Meridian Lakeview

Chapel Hill Town Council

Town Council Feedback from October 11th,2023

Town Council Feedback – Greenway Connectivity

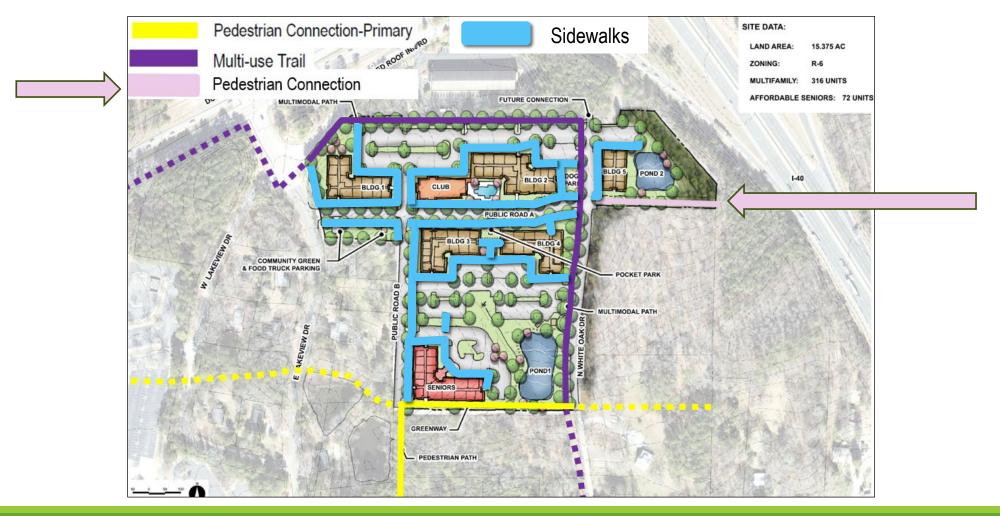
Council Feedback	Responses
 Affordable Housing Questions on LIHTC in Durham County and what happens if not awarded after 5 submissions 	Affordable Housing Scoring and Letter provided by experienced LIHTC Developer & Support from non-LIHTC Affordable Partners
 Greenway Connectivity Council recommended adding a Pedestrian Path to Chapel Hill Crossing Connectivity between buildings 	Greenway Connectivity • Added a Pedestrian Path to Chapel Hill Crossing • Sidewalk Details
 Parking / Impervious Surface Concerns of too much parking and too much impervious surface 	 Parking / Impervious Surface Onsite Parking is 1.07 spaces per unit (45 spaces below town minimum) Meridian Lakeview Impervious is 60%, Town standard is 70% (15 % below town standard)
Recreation Council recommended adding a Playground 	Recreation • Playground added

- Greenway Connectivity
 - Pedestrian path to Chapel Hill Crossing added
